DEVELOPMENT APPLICATION

PDPLANPMTD-2025/053902

PROPOSAL: Two Multiple Dwellings (One New & One Existing)

LOCATION: 20 Kenton Road, Geilston Bay

PROPOSED SITE PLAN		
Drawn	ST	AP2025-2437
Date	23 June 2025	Sheet
Scale	1 : 200	01a/03

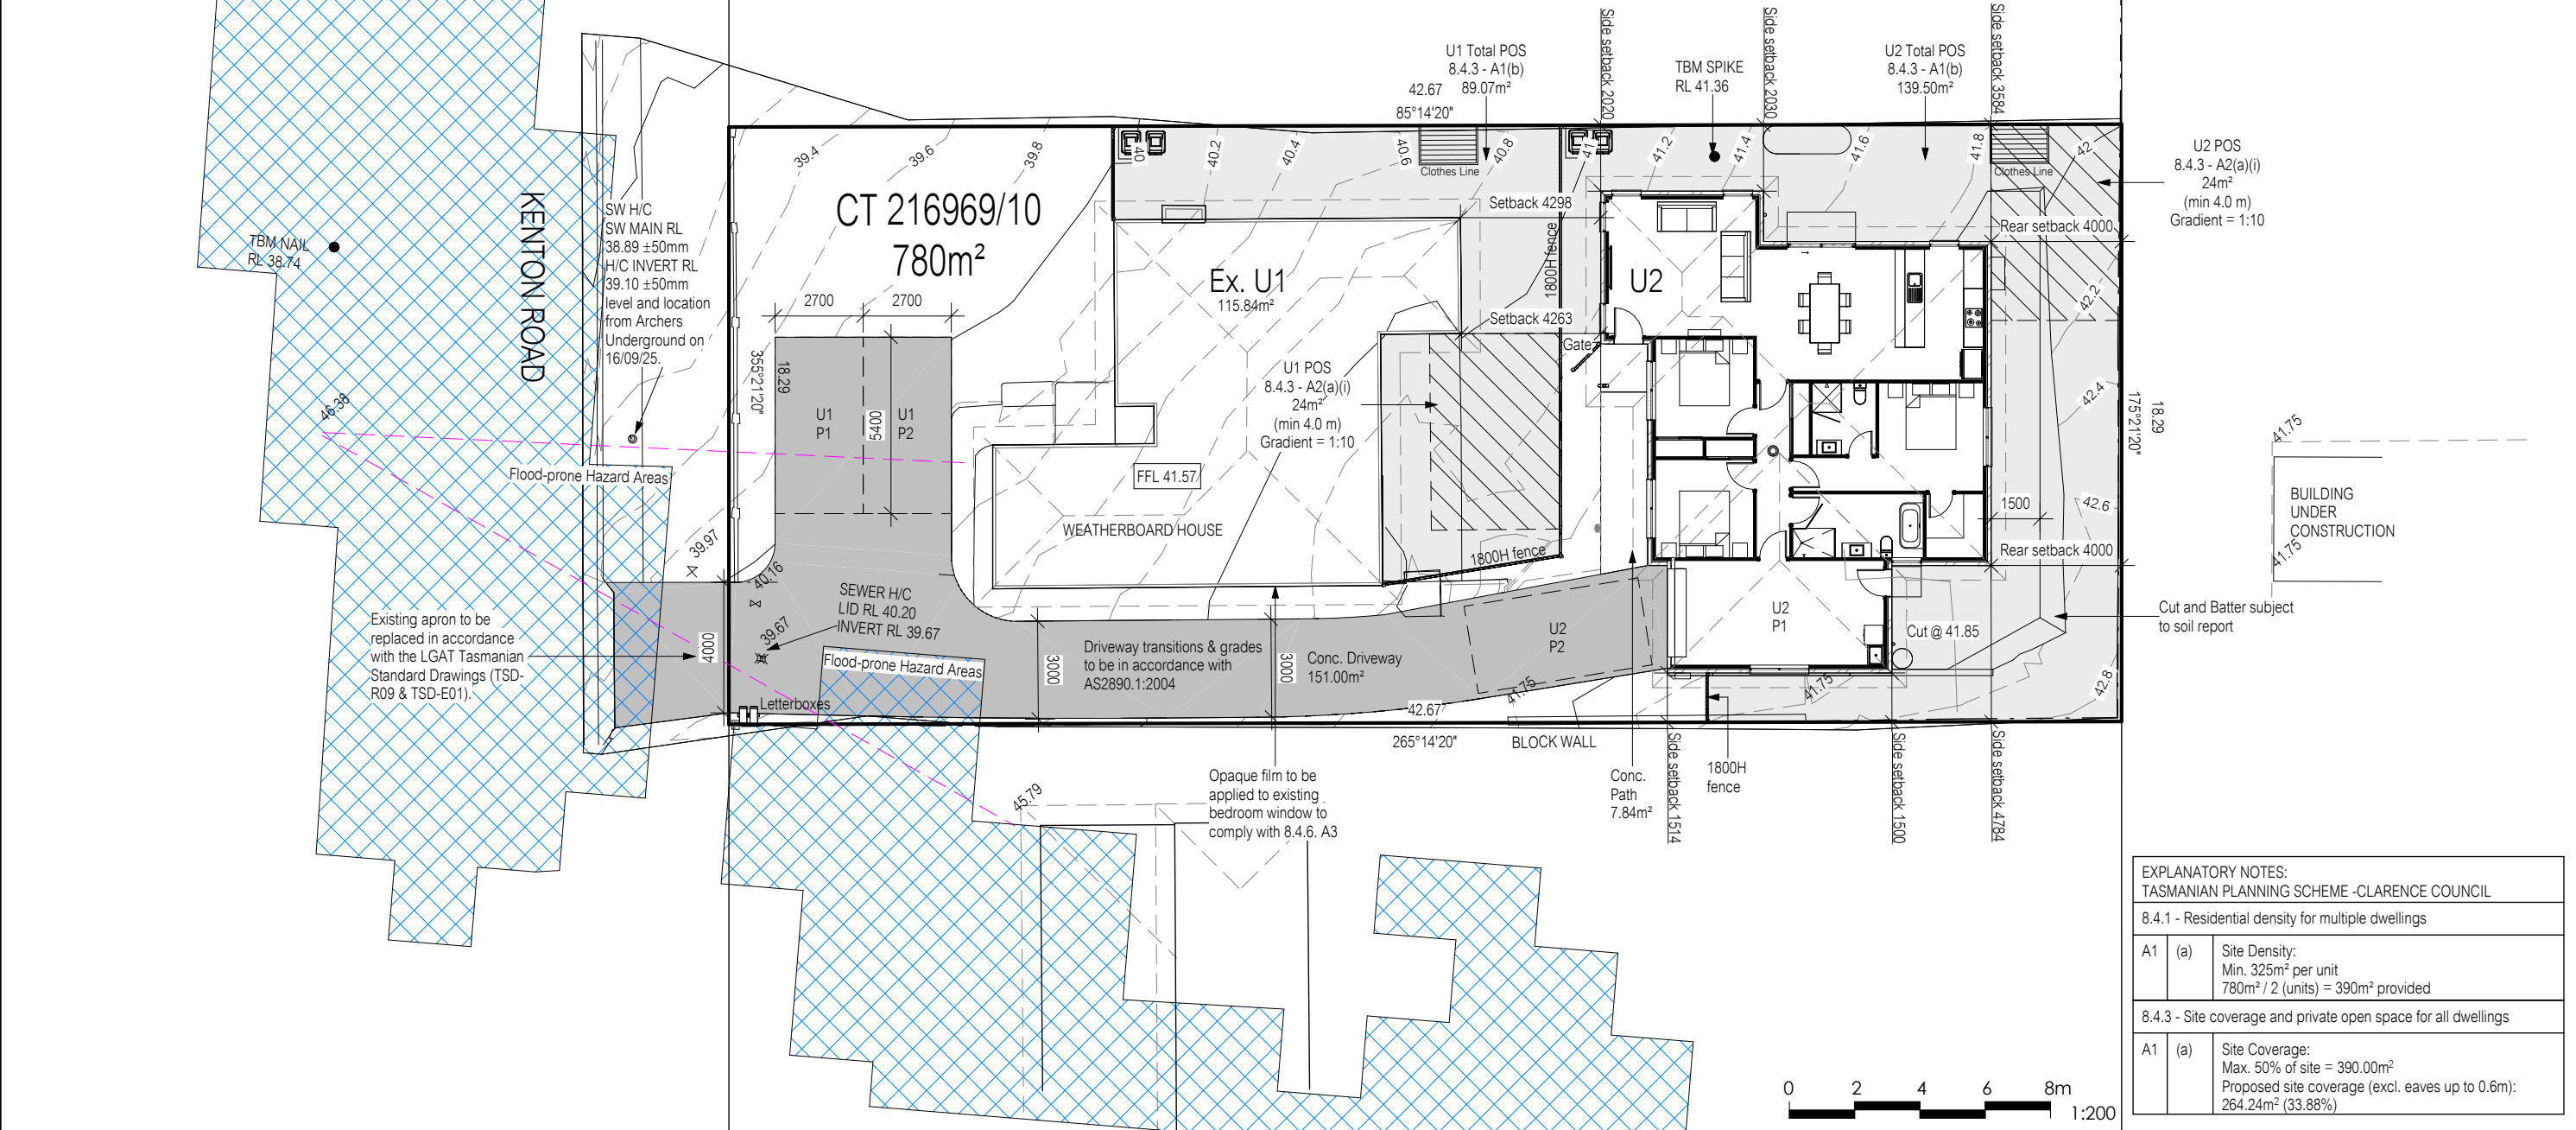
A	Council RFI - note existing crossover to be removed and replaced, show extent of Flood Prone Hazard Area overlay. Update stormwater connection as per revised detail survey.	19 Sept. 2025	ST	CK	01 - 01b
	DA Plan Set	24 June 2025	ST	CK	01 - 03
No.	Amendment	Date	Drawn	Checked	Sheet

Refer to amended Proposed Site Plan (sheet 01a) and Drainage Plan (sheet 01b) showing additional driveway details.

Refer to amended Proposed Site Plan (sheet 01a) showing minimal extent of Flood Prone Hazard Area on the proposed driveway, noting that there is no change of use to the impacted area – the works are limited to replacing an existing section of driveway with a new driveway.

Given there is no change in use and no change in the catchment/obstruction to water flows, there should be no change to the existing level of risk from a flood that is presumably already considered to be tolerable.
